REV	J	APPLICATION			REVISIONS		
		NEXT ASSEMBLY	REV	DESCRIPTION	DATE	APPROVED	APPROVED
SH	1		A	INITIAL RELEASE PER DCN W1612	10/04/01	S.ELLIOTT	----
			B	UPDATE FOR MINOR SOFTWARE REVISION PER DCN W1714	10/31/01	V. Wallace	---
DWG. NO. 150-041116			C	UPDATE FOR MINOR SOFTWARE REVISION PER DCN W1998	06/20/02	S. Wild	V. Wallace
			D	UPDATE FOR MINOR SOFTWARE REVISION PER DCN W1982	10/17/02	VDW	CE/RH
			E	UPDATE FOR MINOR SOFTWARE REVISION PER DCN W2555	12/13/02	V. Wallace	D. Cureton
			F	UPDATE FOR MINOR SOFTWARE REVISION PER DCN W2631	02/29/03	V. Wallace	CE/RH
			G	UPDATE FOR MINOR SOFTWARE REVISION PER DCN W2939	08/2/04	R. Talken	CE/RC
			H	UPDATE FOR MINOR SOFTWARE REVISION PER DCN W4184	02/16/05	R. Talken	R. Hamilton
			J	UPDATE FOR MINOR SOFTWARE REVISION PER DCN W5184	5/9/06	D. Woodhurst	R. Hamilton

The following table specifies the parts required to perform this Service Instruction for C-5000 flavors 31300-0X01-0XXX.

#### A. MODIFICATION OF 31300-0X01-0XXX

**Figure 1. Interface Board Locations**

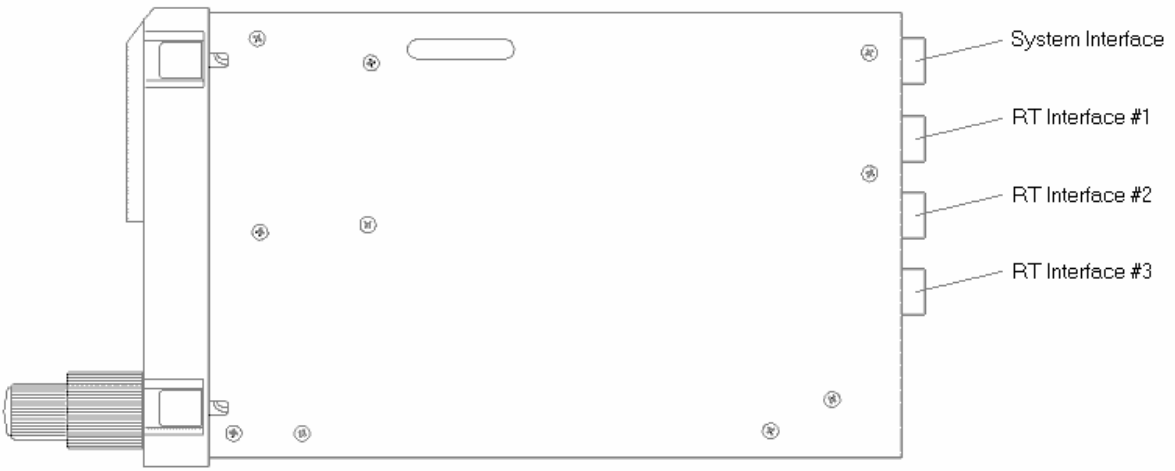
1. Remove the cover from the C-5000 chassis.
2. Replace CPU board, P/N 300-031315, with updated board, P/N 300-017305.
3. If present, remove Serial RT Interface Board 1, P/N 300-016290. See Figure 1. Replace EPROM U25, P/N 106-816929-XX with P/N 106-841135-03. See Figure 2. Reinstall Board.
4. Repeat step 3 for Serial RT Interface Board 2, if present. See Figure 1.
5. If present, remove RT Interface Board 3. See Figure 1. This board should be returned to the customer.
6. Remove System Interface Board, P/N 300-031320-XX. See Figure 1.
7. Verify the System Interface Board is a standard 300-031320-01 (no encryption). If not, convert the board to a standard 300-031320-01 configuration using the following procedures:

3. Install updated EPROMS U201, P/N 106-841141-09, U208, P/N 106-841143-09, and U304, P/N 106-841142-05 onto the CPU board. Reinstall CPU board.
4. If present, remove Serial RT Interface Board 1, P/N 300-016290-XX. See Figure 1. Replace EPROM U25, P/N 106-816929-XX with P/N 106-841135-03. See Figure 2. Reinstall Board.

5. Repeat step 4 for Serial RT Interface Board 2, if present. See Figure 1.
6. If present, remove RT Interface Board 3. See Figure 1. This board should be returned to the customer.

7. Remove System Interface Board, P/N 300-031320-XX. See Figure 1.
8. Verify the System Interface Board is a standard 300-031320-01 (no encryption). If not, convert the board to a standard 300-031320-01 configuration using the procedures in step A.7.

**Figure 3. Key Legend Locations**

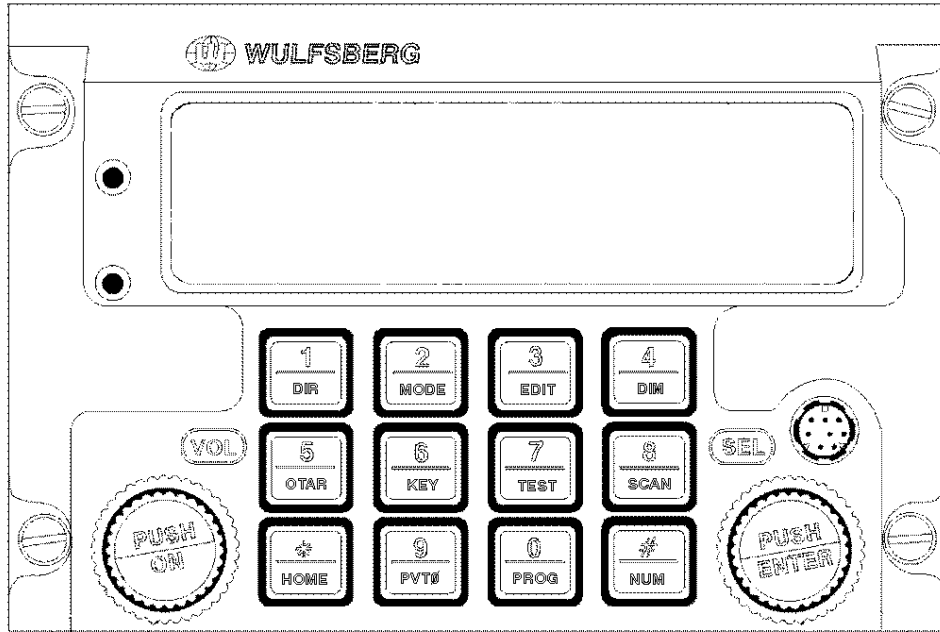
9. Verify the System Interface Board has the Automatic Level Control (ALC) circuit. If not, apply EO 2297.
10. Reinstall System Interface Board.
11. Install updated key legend, P/N 156-031345-02, per Figure 3.
12. Reinstall cover on the C-5000 chassis.
13. Affix the new Control Head and Software Mod labels. Transfer the unit serial number to the new label and mark a capital "M" in front of the serial number.

**Figure 4. EPROM Locations, CPU board**

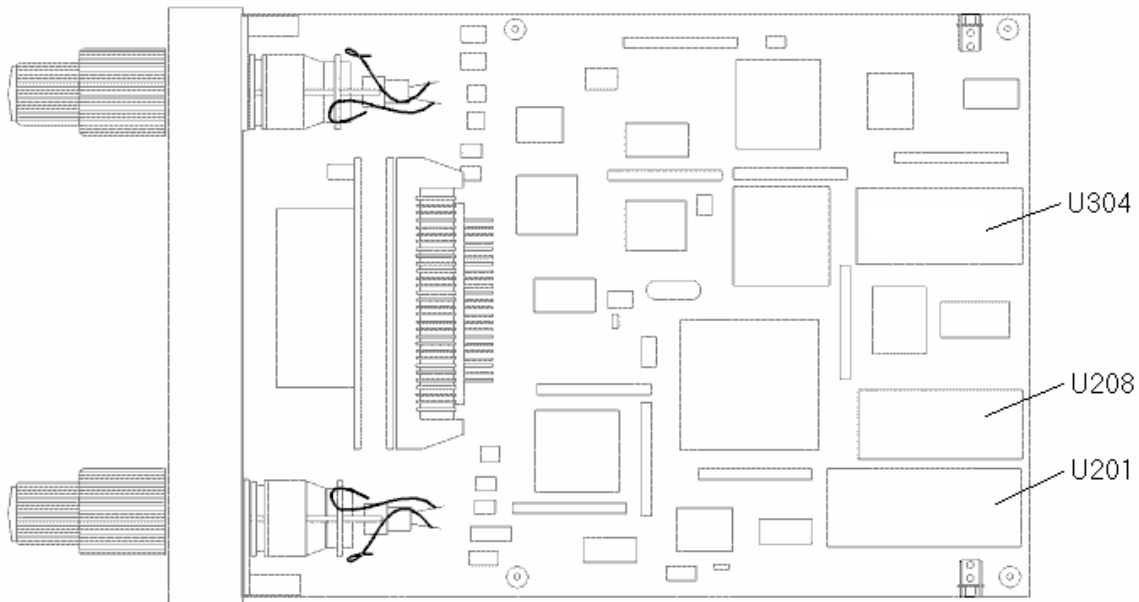
1. Remove the cover from the C-5000 chassis.
2. Remove EPROMS U201, P/N 106-816662-XX, U208, P/N 106-816664-XX, and U304, P/N 106-816663-XX from the CPU board. See Figure 4.

FIGURE 5.

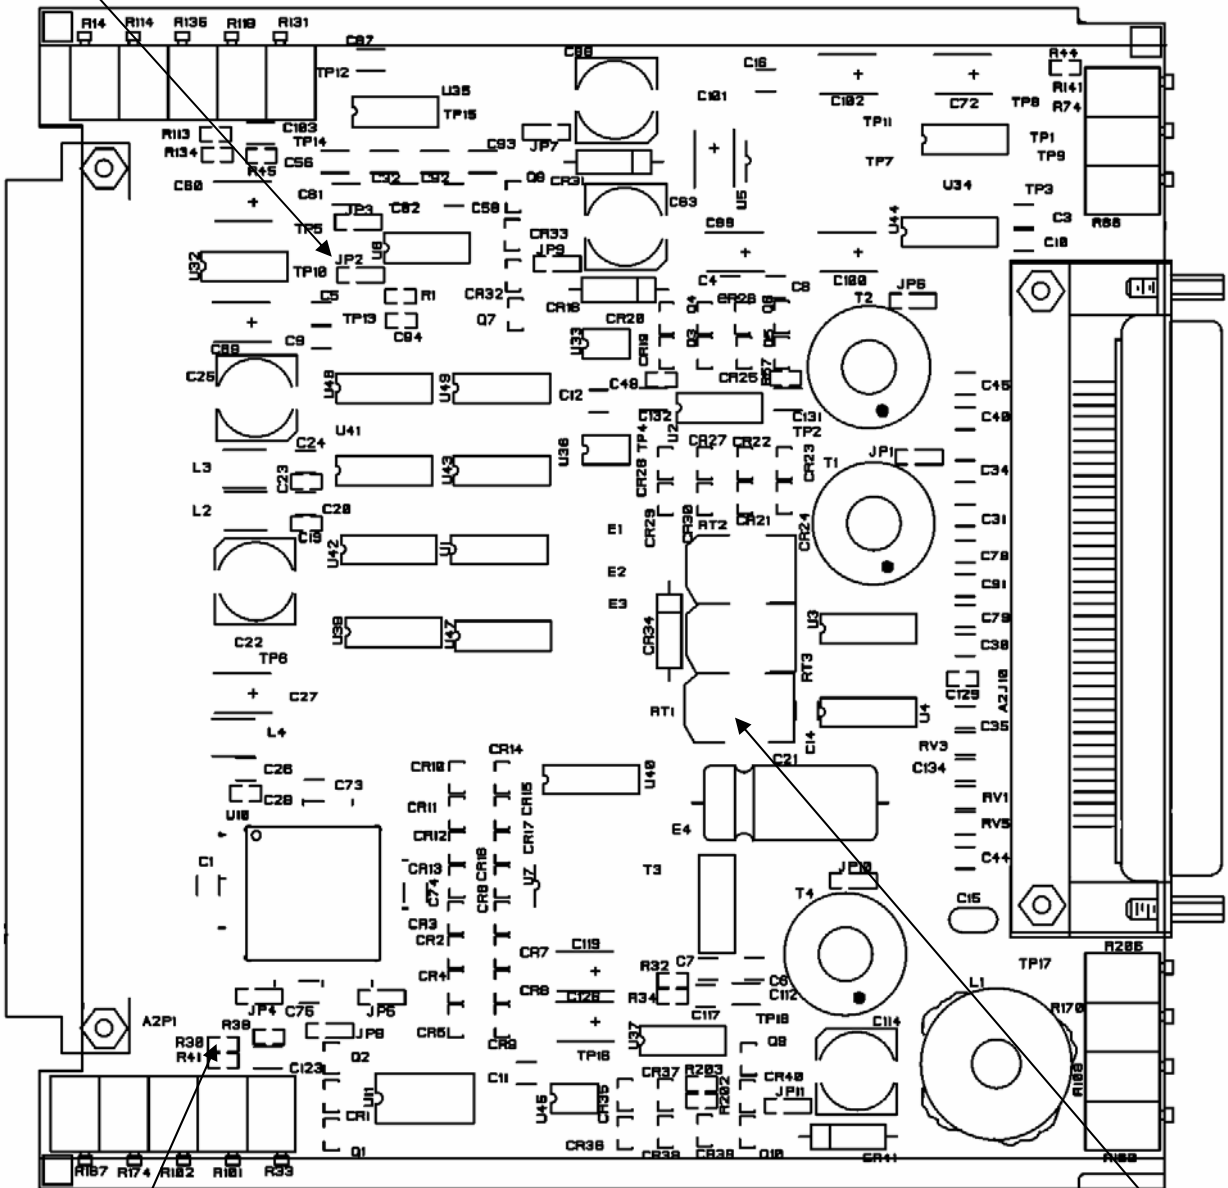
- e. System Interface Module 300-031320-02 Rev P or later (See Figure 5)  
Install R30, 0 ohm resistor, P/N 234-040024-0000.  
Move resistor on JP2 from position 2-3 to 1-2.  
Remove RT1.  
Change board identification from 300-031320-02 to -01.
8. Verify the System Interface Board (prior to Rev. P) has the Automatic Level Control (ALC) circuit (See Figure 6). If not, apply EO 2297.
9. Reinstall System Interface Board.
10. Install updated key legend, P/N 156-031345-02, per Figure 3.
11. Reinstall cover on the C-5000 chassis.
12. Affix the new Control Head and Software Mod labels. Transfer the unit serial number to the new label and mark a capital "M" in front of the serial number.

FIGURE 6  
TOP VIEW

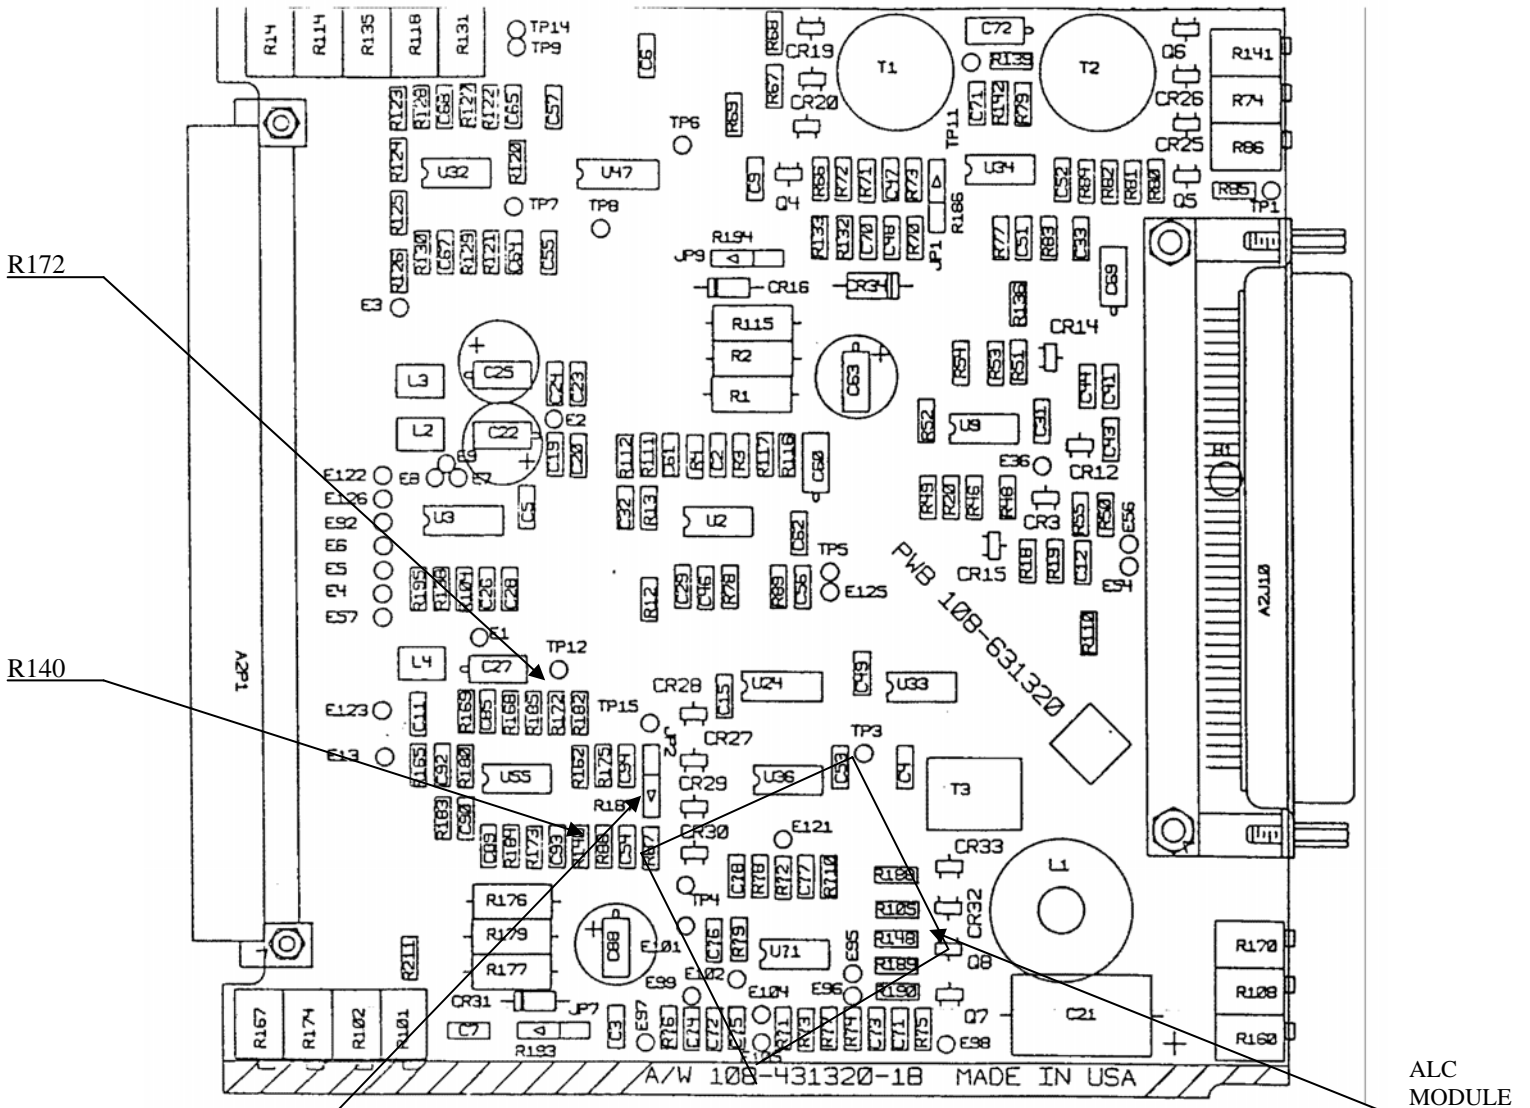
#### **P/N 31300-0X01-0XXX with Mod 7 and/or Mod 19** (See Figure 6 and 7)

- a. System Interface Module 300-031320-01 without ALC Module attached  
Remove R187, P/N 234-014791-0000 from JP2 pads 2-3 and move to JP2 pads 1-2.  
Remove R196 if present.  
Remove R192, P/N 234-014791-0000 from JP3 pads 2-3 and move to JP3 pads 1-2.  
Replace R172 resistor with 3.65K ohm resistor, P/N 139-03651-0000.
- b. System Interface Module 300-031320-01 with ALC Module attached  
Remove ALC E2 wire from JP2 and connect to pad of R140 closest to JP7.  
Perform steps in procedure (a) above.
